Wisconsin Department of Transportation

Proposal #14: 2150-00-71, WISC 2021 142
Brown Deer Rd C Milw & V Brwn Deer
91st Street to Deerbrook Trail
STH 100
Milwaukee County

This is Addendum No. 01, which provides for the following:

ADDENDUM NO. 01

Figure 1: Nuclear/Core Correlation Location Layout

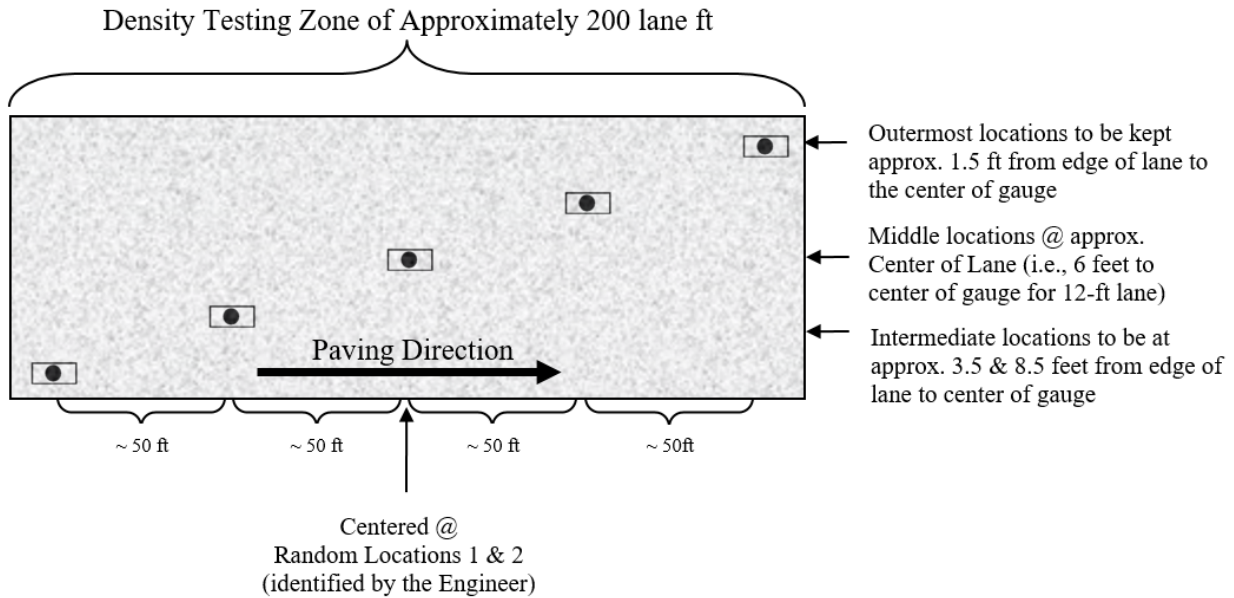
The engineer will identify two zones in which gauge/core correlation is to be performed. These two zones will be randomly selected within each *half* of the test strip length. (Note: Density zones shall not overlap and must have a minimum of 100 feet between the two zones; therefore, random numbers may be shifted (evenly) in order to meet these criteria.) Each zone shall consist of five locations across the mat as identified in Figure 1. The following shall be determined at each of the five locations within both zones:

Individual locations are represented by the  symbol as seen in Figure 1 above. The symbol is two-part, comprised of the nuclear test locations and the location for coring the pavement, as distinguished here:

Figure 4: Locations of main lane HMA density testing (QC=solid lines, QV=dashed)

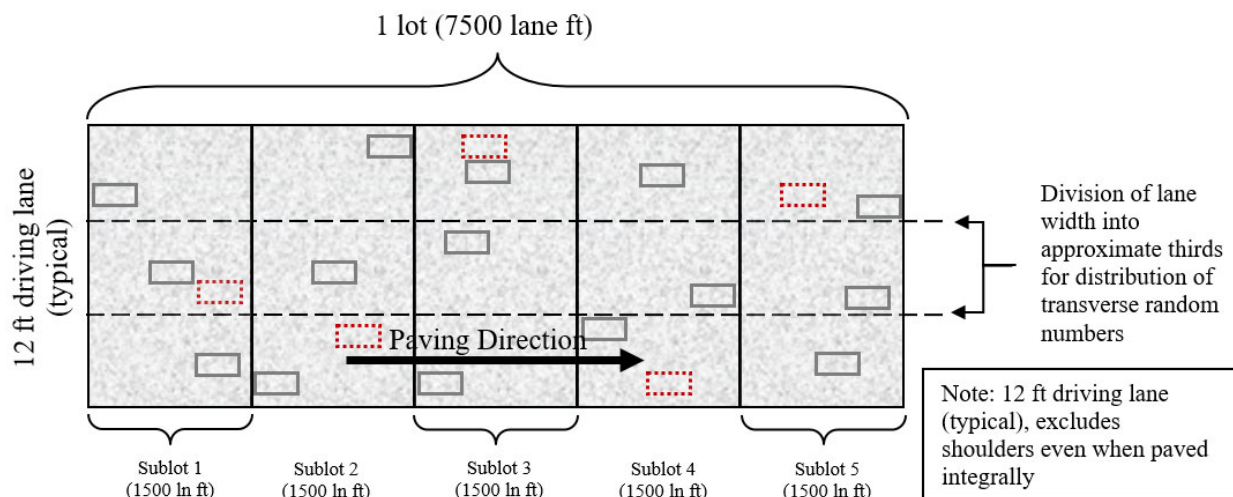
For nuclear density testing of the pavement beyond the test strip, QC tests will be completed at three locations per subplot, with a subplot defined as 1500 lane feet. The three locations will represent the outside, middle, and inside of the paving lane (i.e., the lane width will be divided into thirds as shown by the dashed longitudinal lines in Figure 3 and random numbers will be used to identify the specific transverse location within each third in accordance with CMM 8-15). Longitudinal locations within each subplot shall be determined with 3 independent random numbers. The PWL Density measurements do not include the shoulder and other appurtenances. Such areas are tested by the department and are not eligible for density incentive or disincentive. Each location will be measured with two one-minute gauge readings oriented 180 degrees from one another, in the same footprint as detailed in Figure 2 above. Each location requires a minimum of two readings per gauge. The density gauge orientation for the first test will be with the source rod towards the direction of paving. QV nuclear testing will consist of one randomly selected location per subplot. The QV is also comprised of two one-minute readings oriented 180 degrees from one another. For both QC and QV test locations, if the two readings exceed 1.0 pcf of one another, a third reading is conducted in the same orientation as the first reading. In this event, all three readings are averaged, the individual test reading of the three which falls farthest from the average value is discarded, and the average of the remaining two values is used to represent the location for the gauge. The subplot density testing layout is depicted in Figure 4, with QC test locations shown as solid lines and QV as dashed.

WisDOT Longitudinal Joint – Nuclear Gauge Density Layout

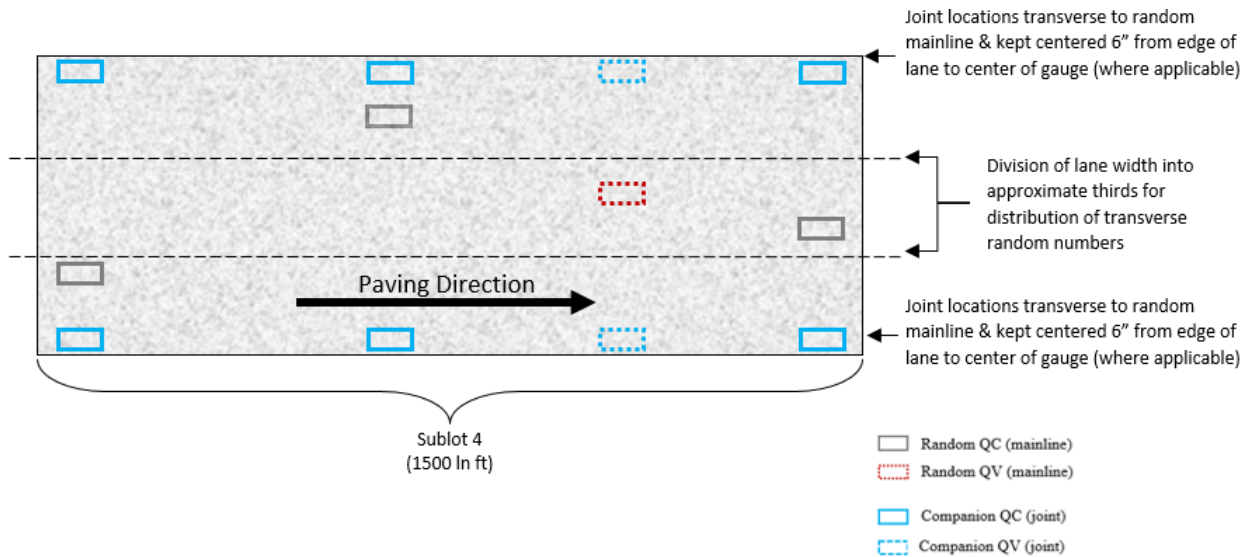
Each QC and QV density location must have a companion density location at any applicable joint. This companion location must share longitudinal stationing with each QC or QV density location and be located transversely with the center of the gauge 6-inches from the edge of the paving area.

For HMA Pavement Percent Within Limits QMP projects, this appears as follows:
